Engineering Surveys and Services

Addendum No.: Two (02)
Project: Downtown Streetscape Phase IIIa
Federal Project No. STP 5700(509)
Date: February 18, 2014
(Page 1 of 2 with attachments)

The following changes, additions, modifications, information and clarification are hereby made to the Contract Documents dated December 27, 2013, revised February 14, 2014, and shall be incorporated in preparation of all Proposals for the Work.

C1.01

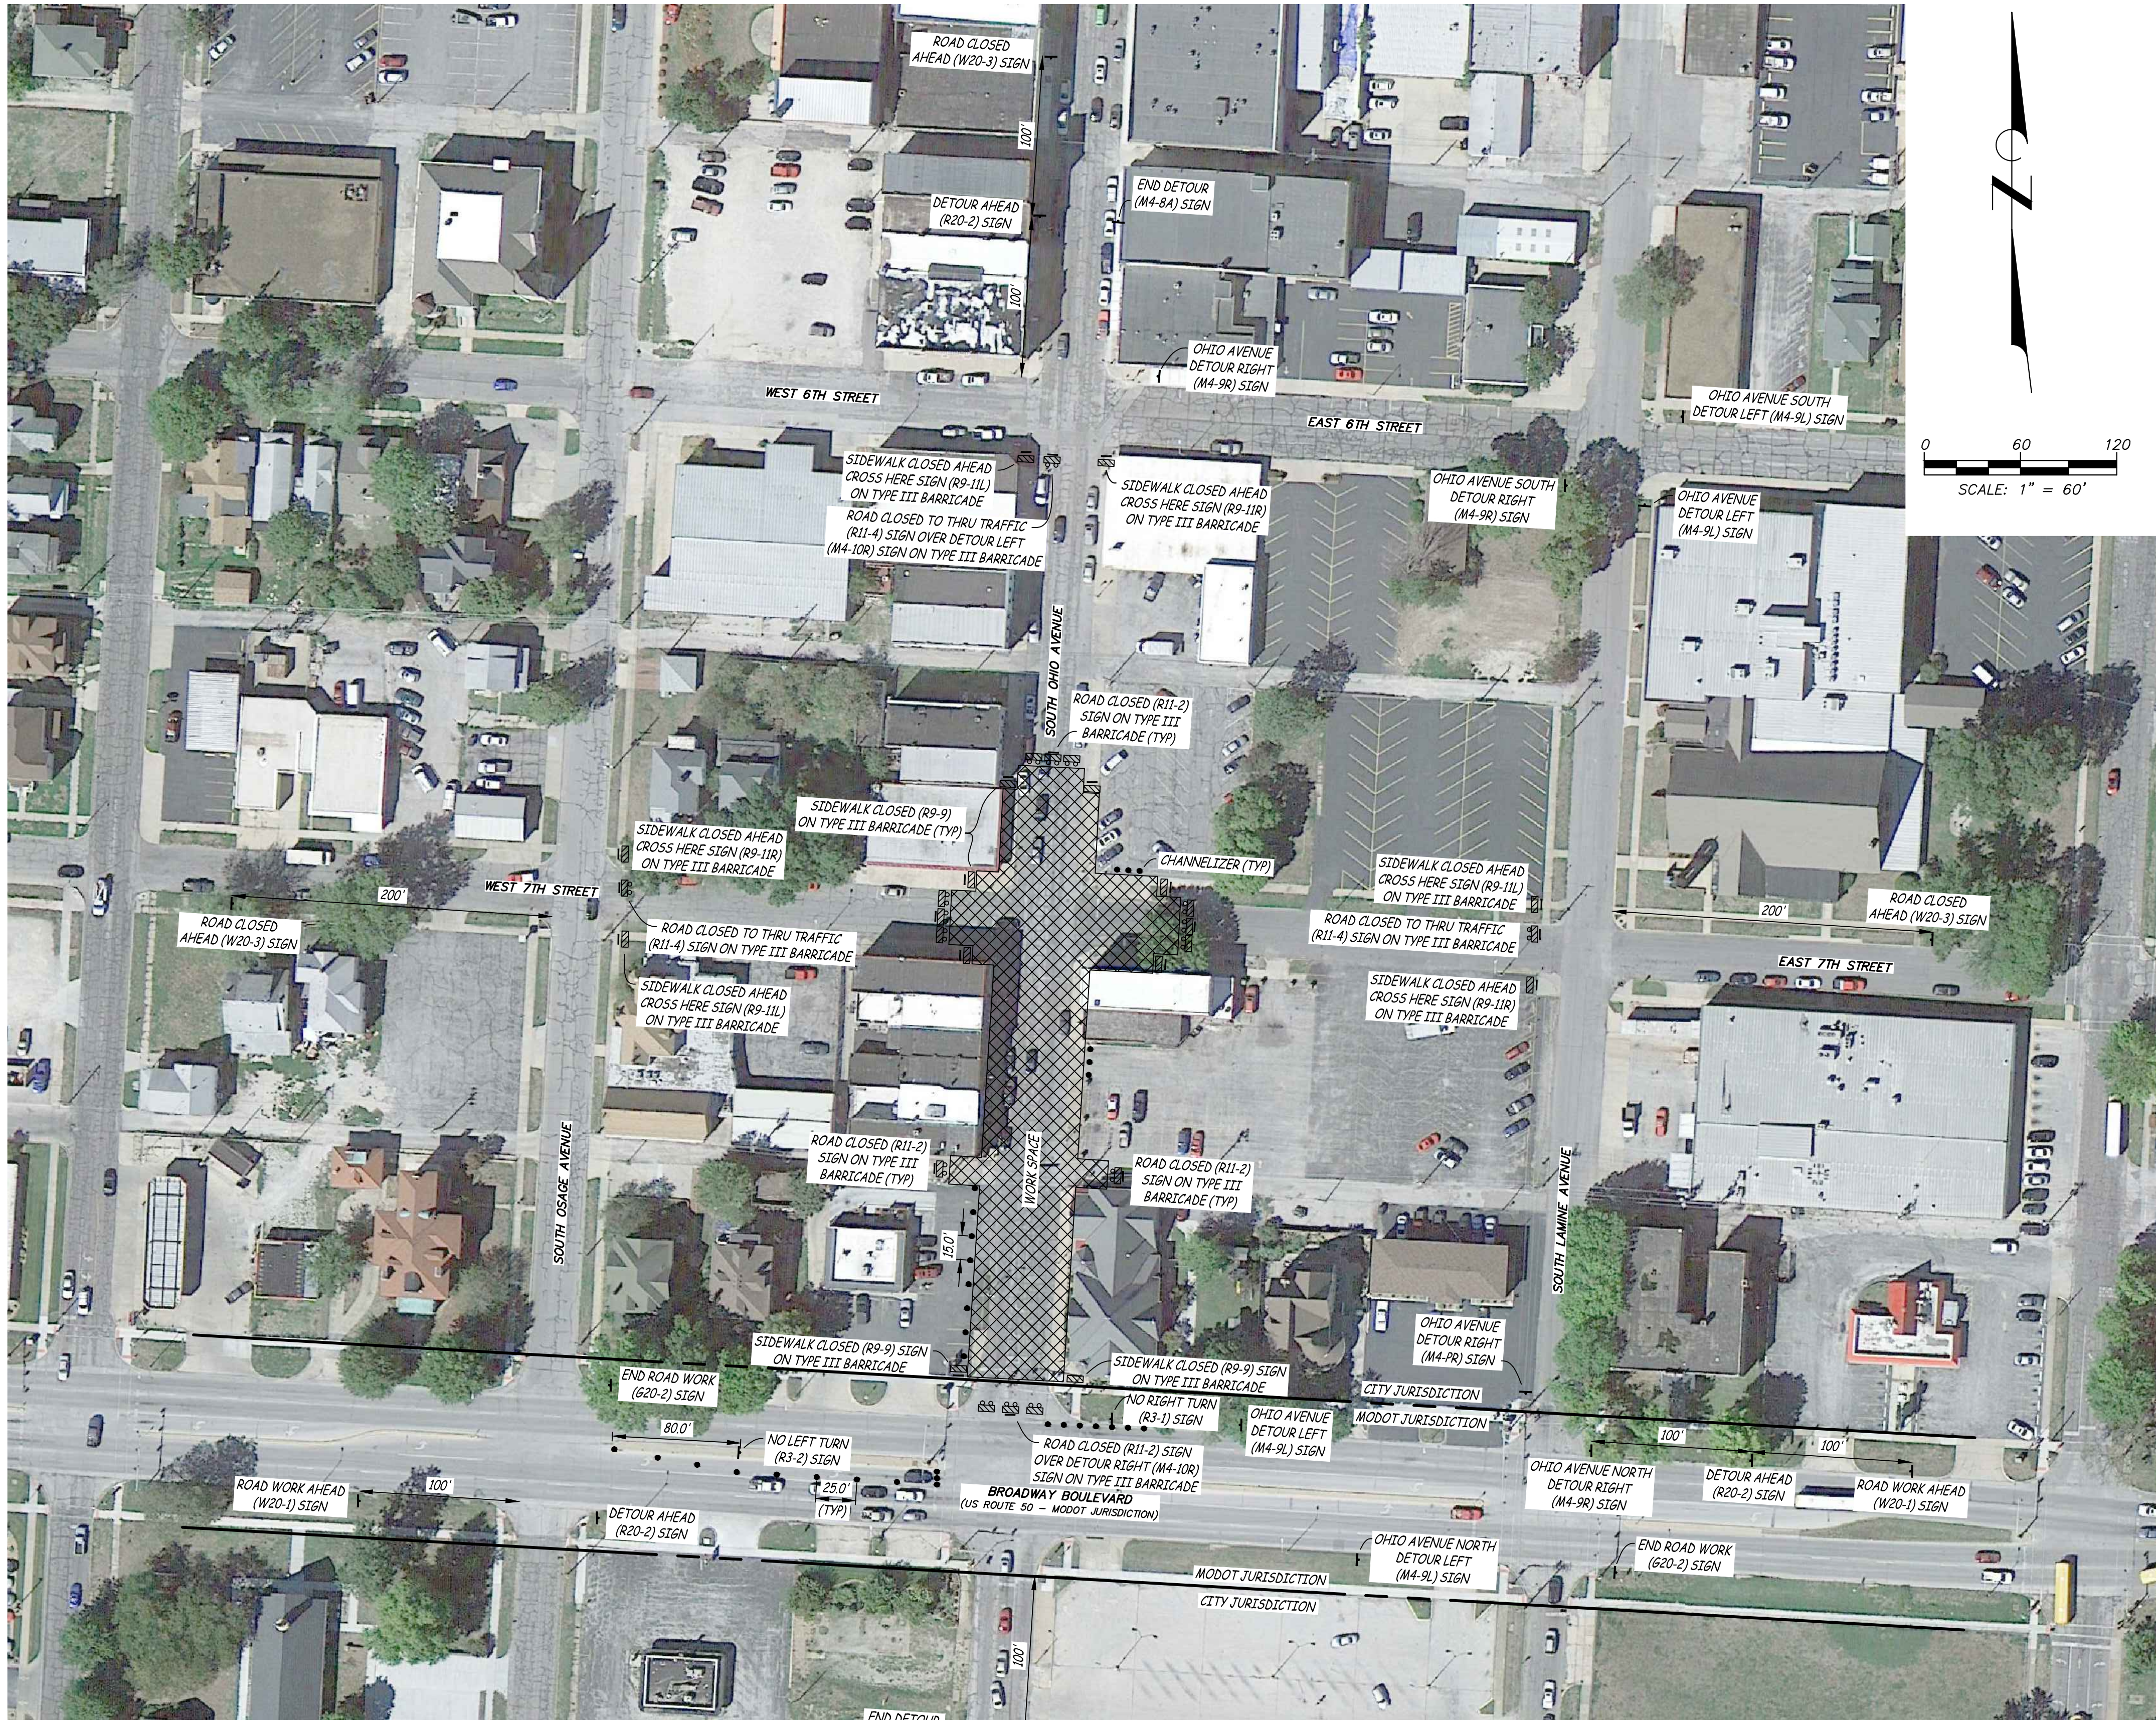
- Temporary Traffic Control Plan, Sheet C1.01

- A permit from MoDOT will need to be obtained by the contractor prior to construction for the work in MoDOT right-of-way, as on the TTC plan. The MoDOT Kansas City District permit contact is Vernon Koch: (816) 607-2190.

- Temporary Traffic Control (TTC) has been changed from a Lump Sum item to a breakdown of the traffic control devices according to the TTC plan.
- Handrail for Sidewalk ADA Ramp has been removed. The handrail at sidewalk ramps will be provided and installed by the City of Sedalia in accordance with Addendum One.
- Pavement Striping has been included as a line item.
- The quantity for Standard Duty Concrete Pavement has been updated.
- 4-inch conduit has been included as a line item.
- In addition to Reinforced Concrete Pipe, HDPE Pipe will be considered as an alternate for storm sewer pipe.
- An alternate in which the Contractor additionally salvages and palletizes the brick pavers underlying the existing asphalt pavement for future use by the City of Sedalia.
